VIRTUAL MEETING OF THE BIRMINGHAM PLANNING BOARD
WEDNESDAY, JUNE 23, 2021
7:30 PM

City Of Birmingham
Regular Meeting Of The Planning Board
Wednesday, June 9, 2021

SUBJECT: 35001 & 35075 Woodward – The Maple – Final Site Plan and Design Review

FIRST FLOOR PLAN

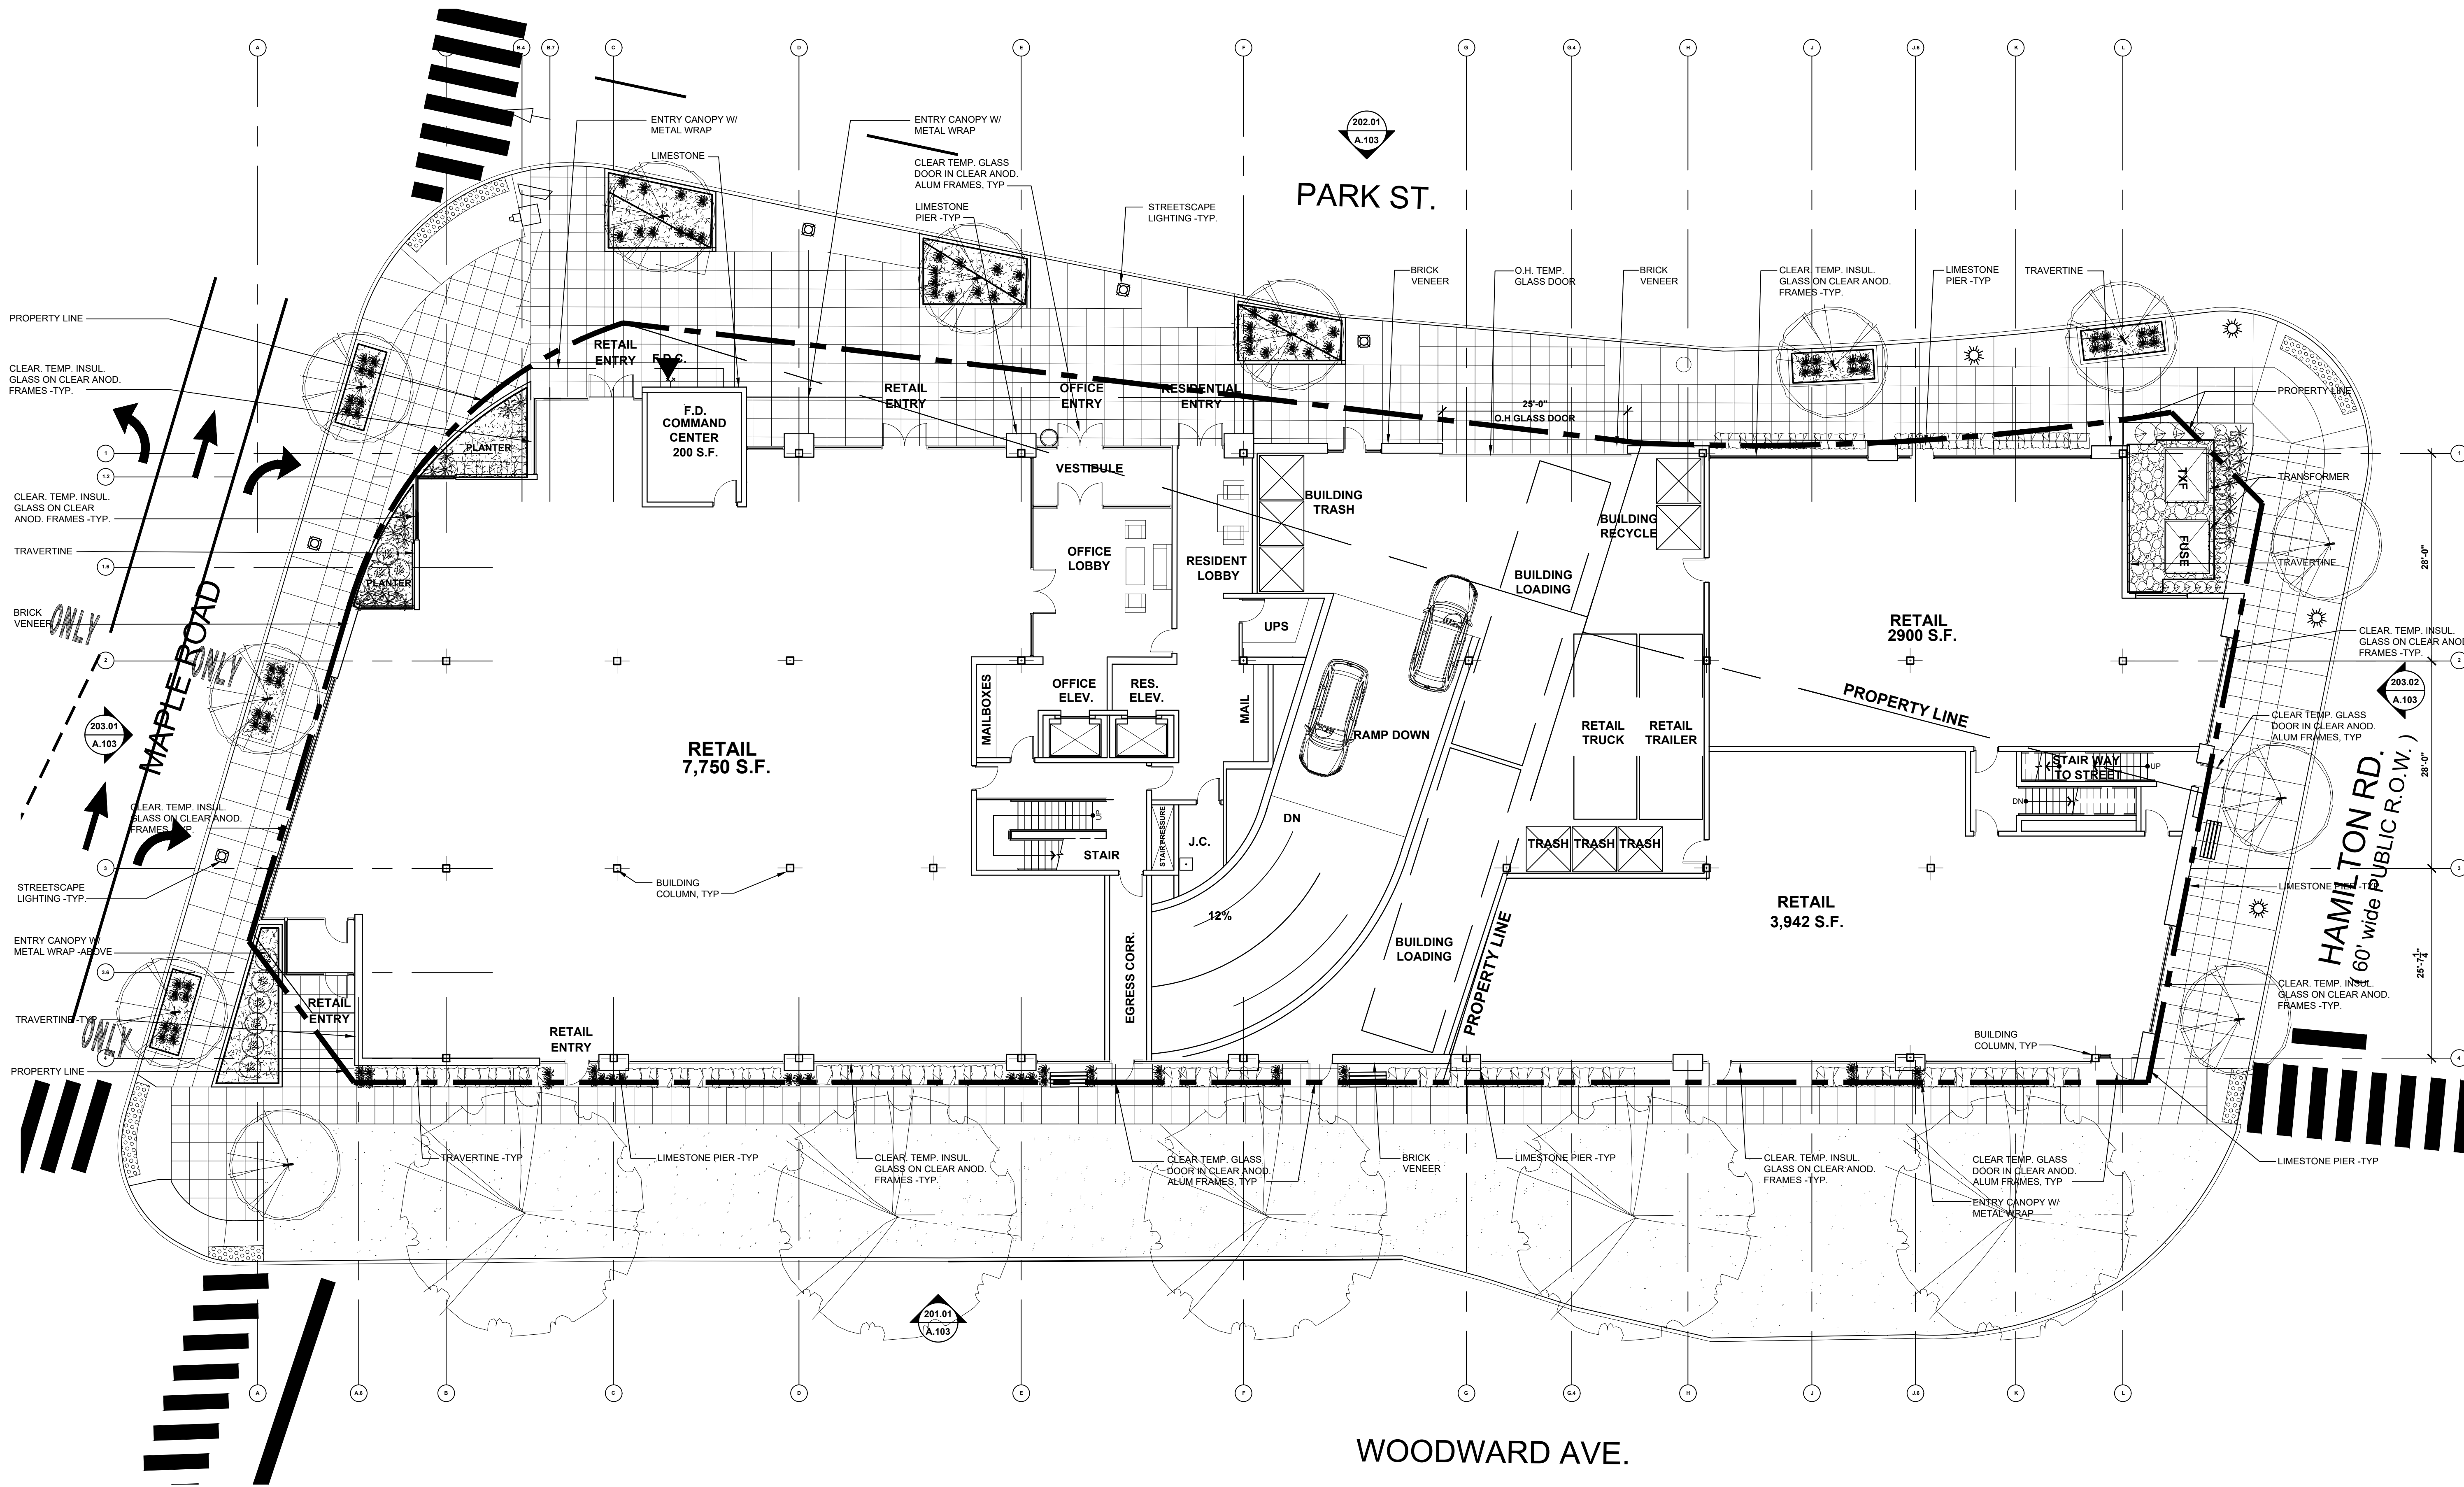
On May 13, 2020, out of an abundance of caution, City staff brought the Preliminary Site Plan back to the Planning Board, and re-noticed it after discovering that the first floor plan displayed at the April Zoom meeting was an older version. Although the correct version was published in the agenda packet and discussed at the April meeting, the matter was reintroduced and the correct first floor plan was displaying over Zoom. The Planning Board voted unanimously on a motion to amend the motion made on April 22, 2020, to approve the Preliminary Site Plan for 35001 and 35075 Woodward by affirming conditions 1 through 8 and adding condition 9 to the approved motion as follows:

- 9) Approved plans include the first floor plan on sheet A101, with the revision date 4-3-20, subject to replacement of the terms "Hunter House" and "HH" throughout the report and the plans with a more generic designation of the planned use of the space.

ROOF PLAN

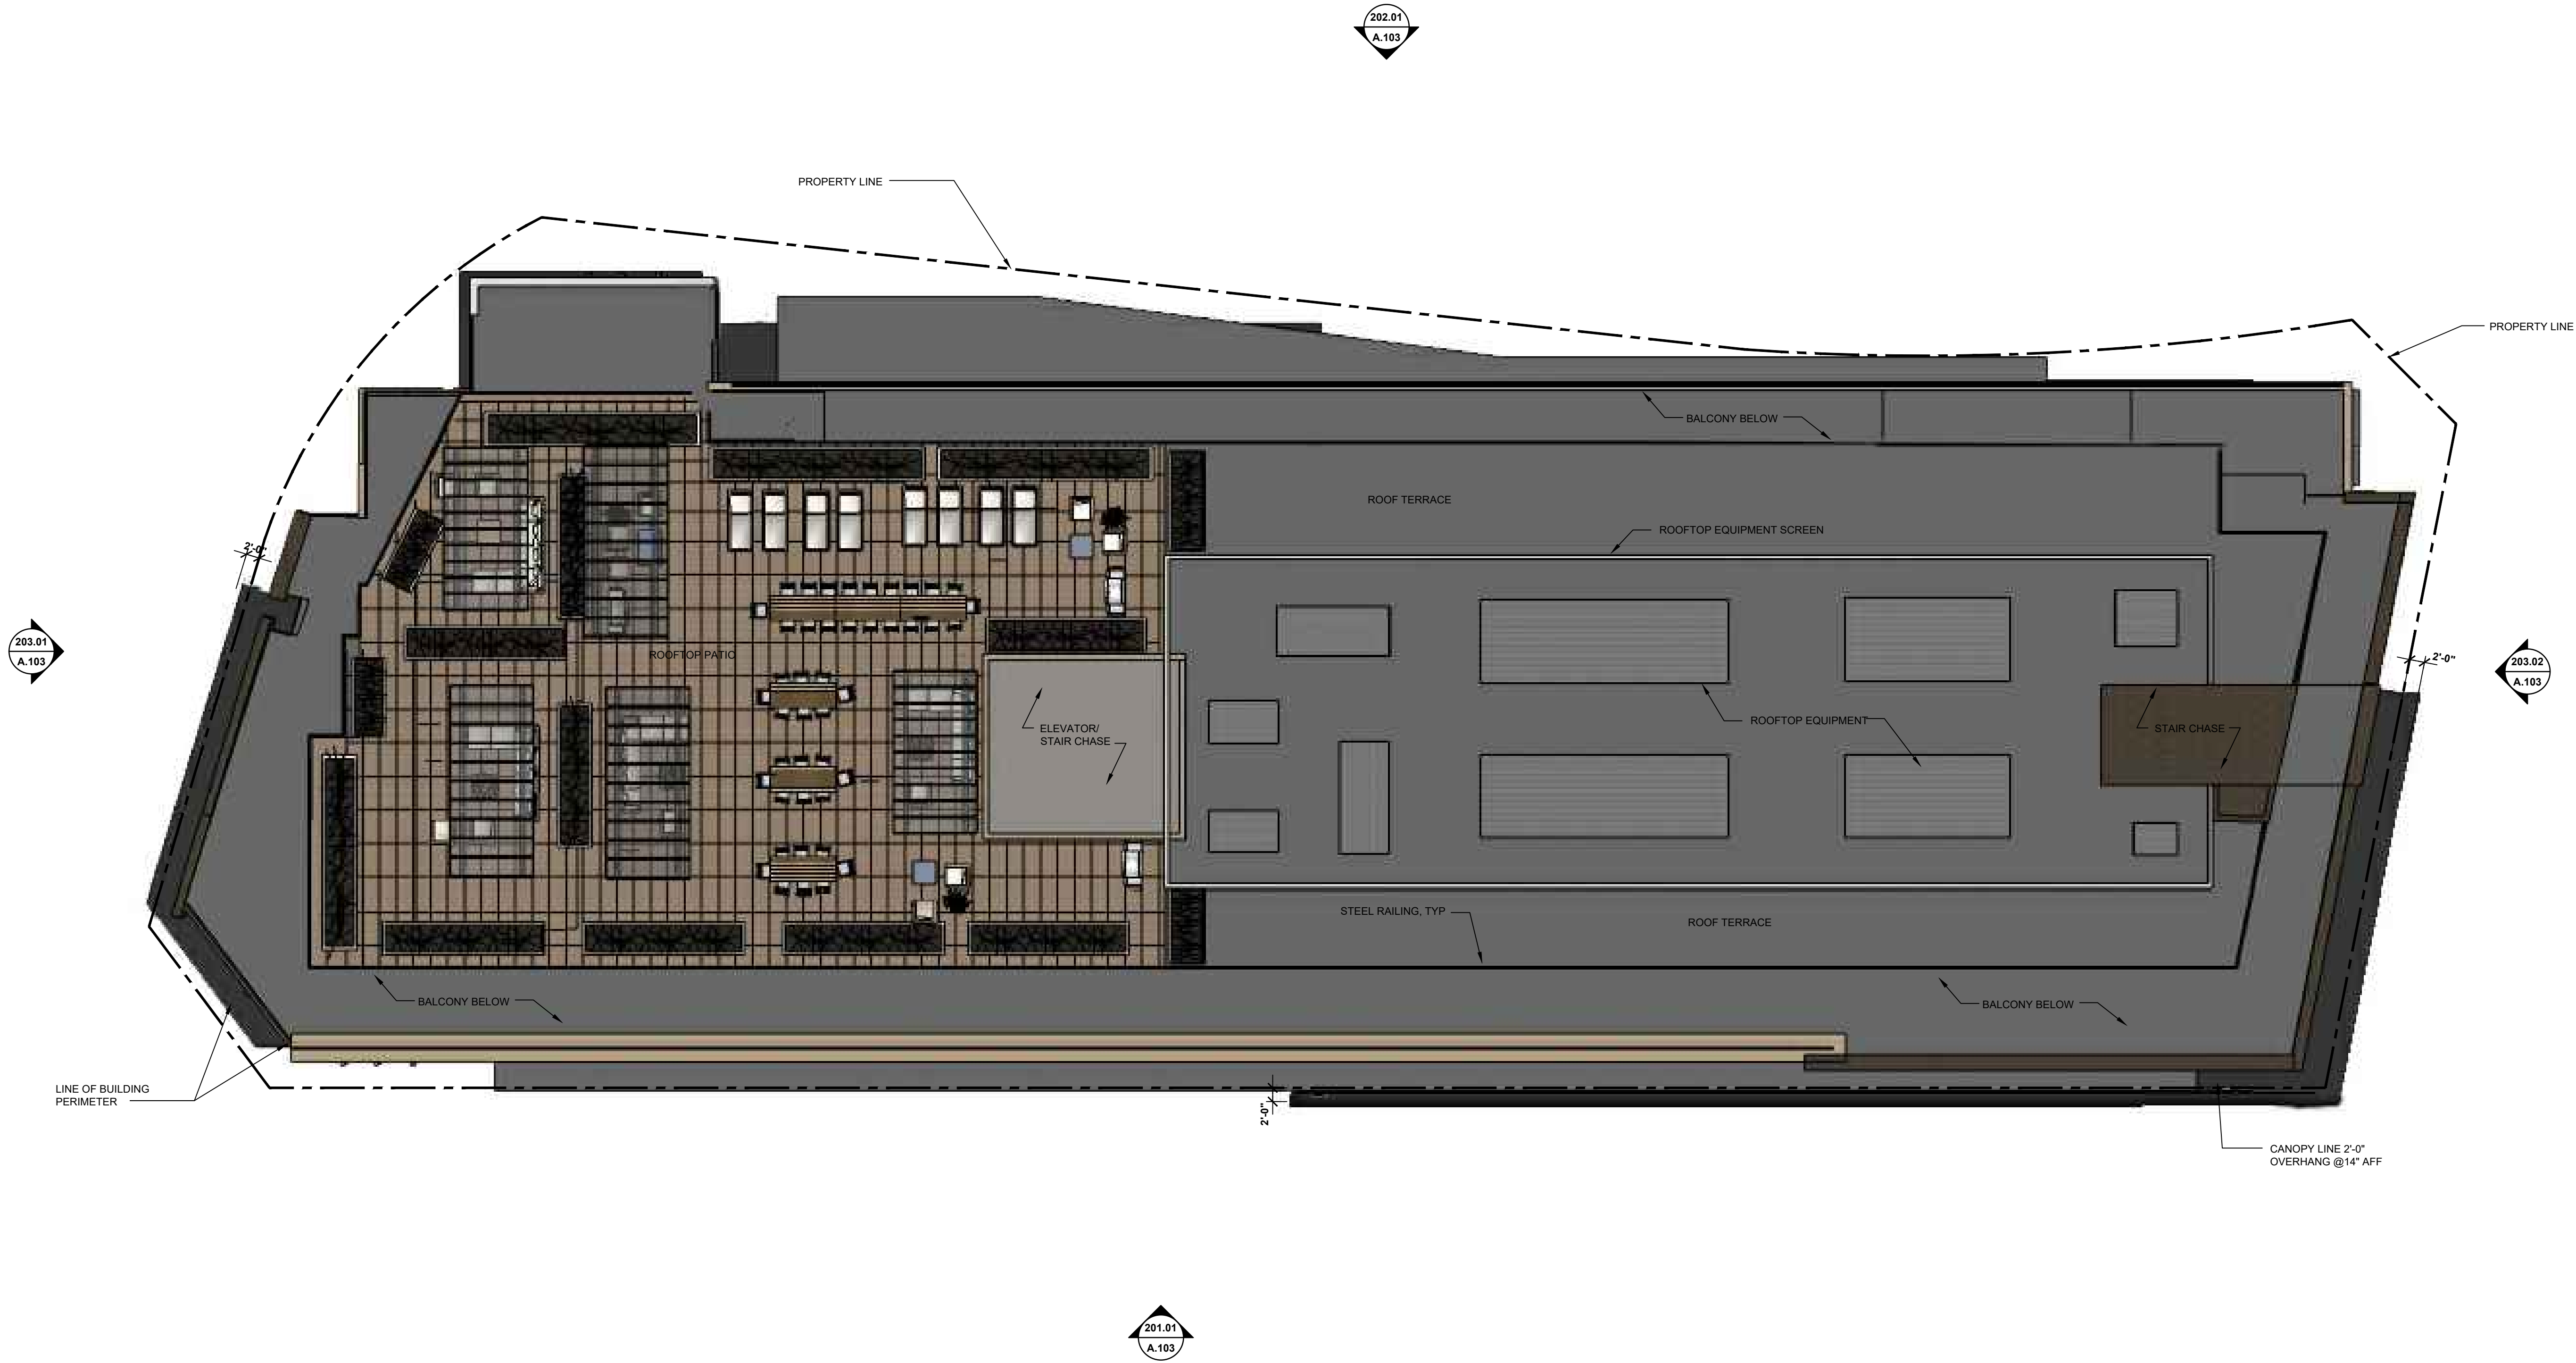
- 3.3 Mechanical Equipment Screening – The applicant has submitted a rooftop plan for the proposed development showing the location of all proposed rooftop units (RTU) and the proposed screening. The screening proposed is 10.6' in height. **In accordance with Article 4, Section 4.54 (C)(8)(c)(ii), rooftop screening may not exceed 10' in height and thus the applicant will be required to reduce the screening to 10' or obtain a variance from the Board of Zoning Appeals.** The applicant has provided a roof plan showing all RTUs and has now provided dimensions and specifications on the RTUs proposed. They are just under 7' in height, and will be fully screened by the required 10' height of the screen walls.

A.201

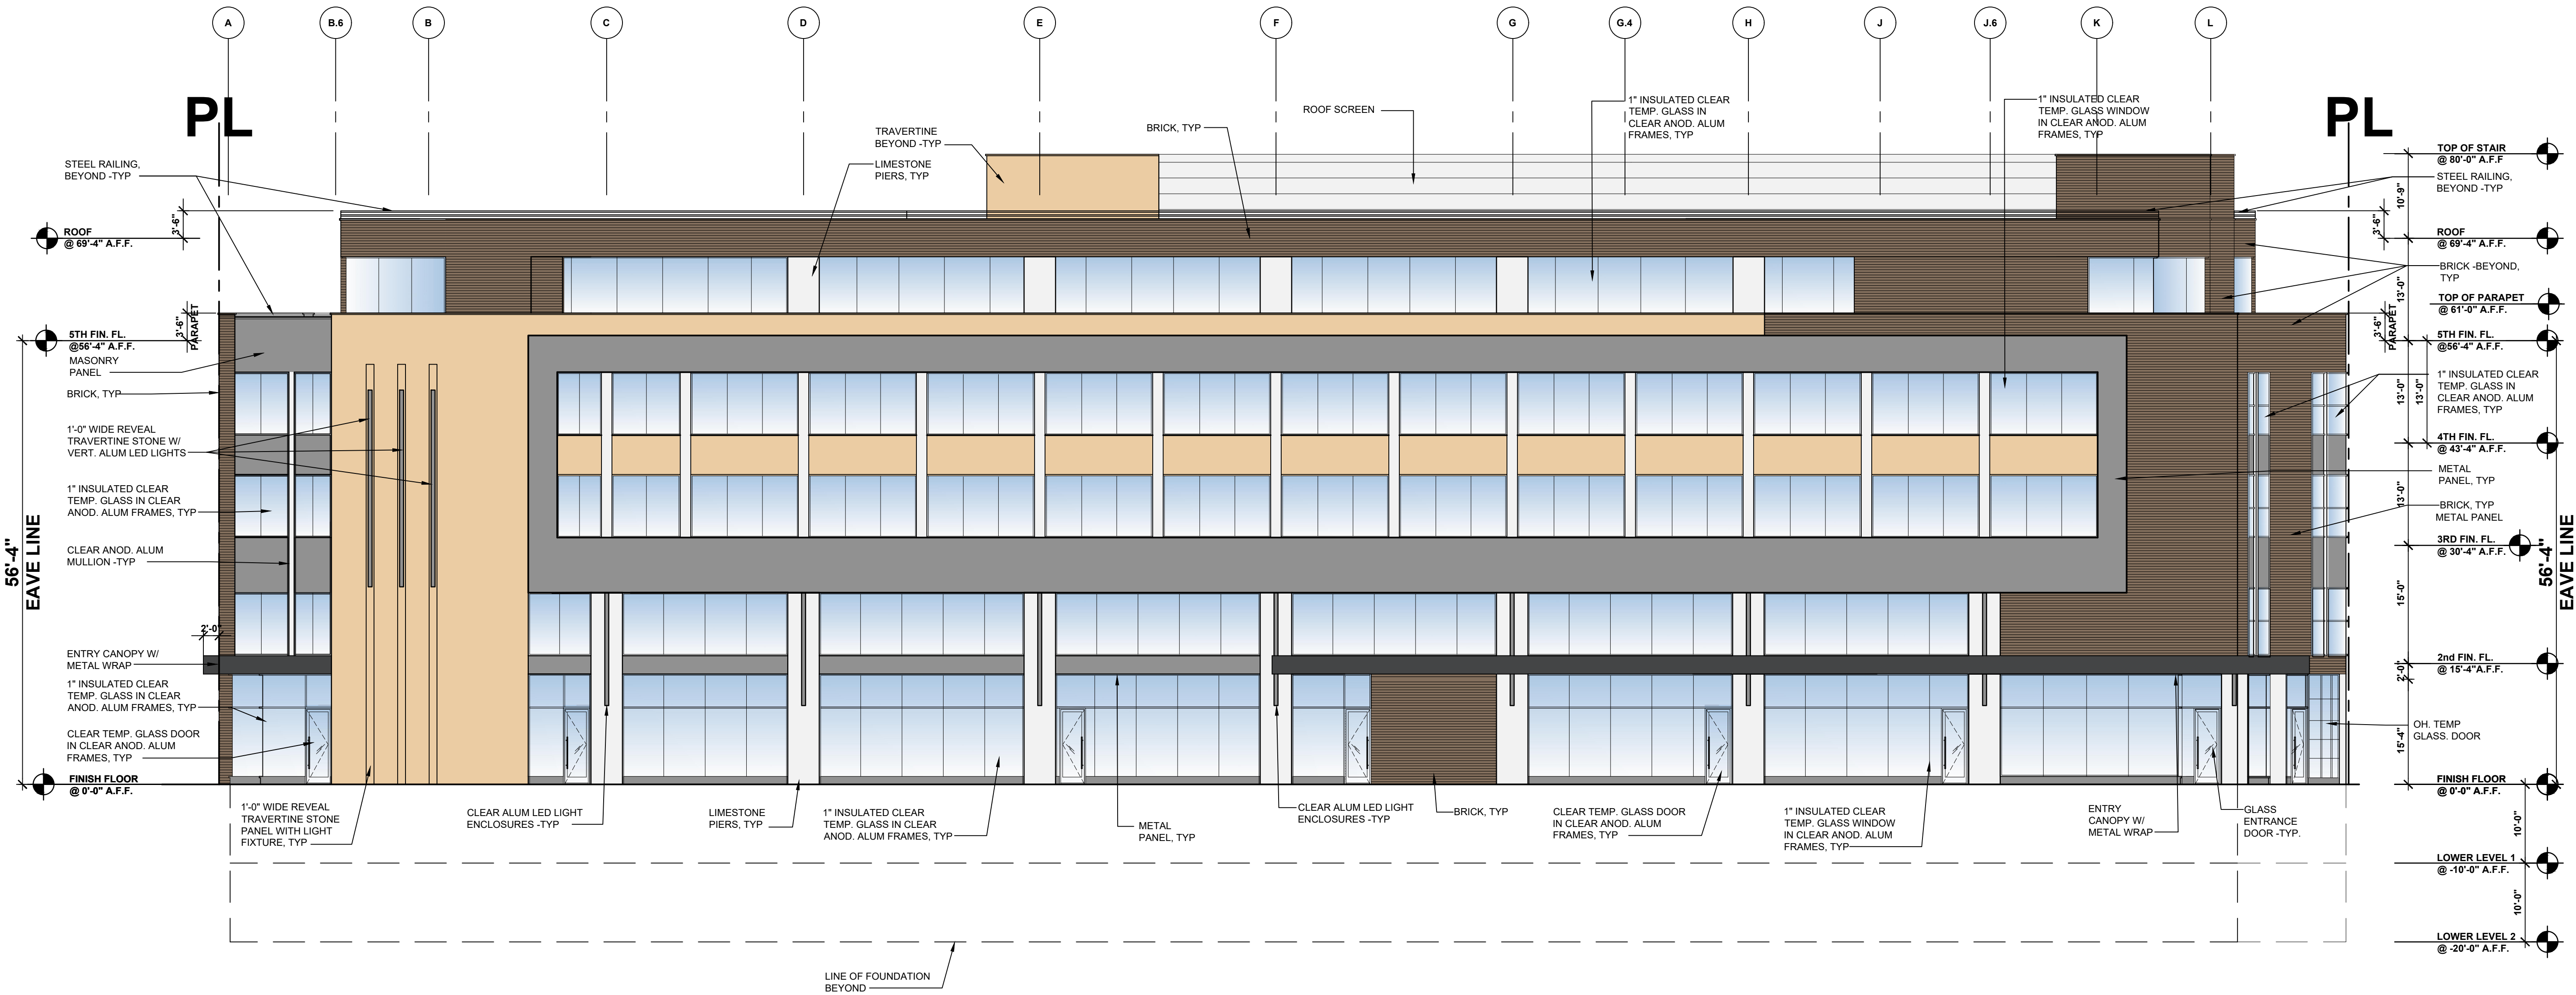
The Planning Board may wish to request additional sizing information on the proposed utility sized brick, and the applicant will be required to provide further specifications on the clear glazing to ensure that the required VLT levels are met. As per Article 3.04(E) of the Zoning Ordinance, no less than 70% of the storefront/ground floor façade between 1 and 8 feet above grade shall be clear glass panels and doorways, and no more than 35% of the upper levels shall be glazed area. The applicant has submitted the following glazing calculations for the proposed development:

6. The applicant provide dimensions for the proposed utility sized brick, and further specifications on the clear glazing and obtain administrative approval for same;
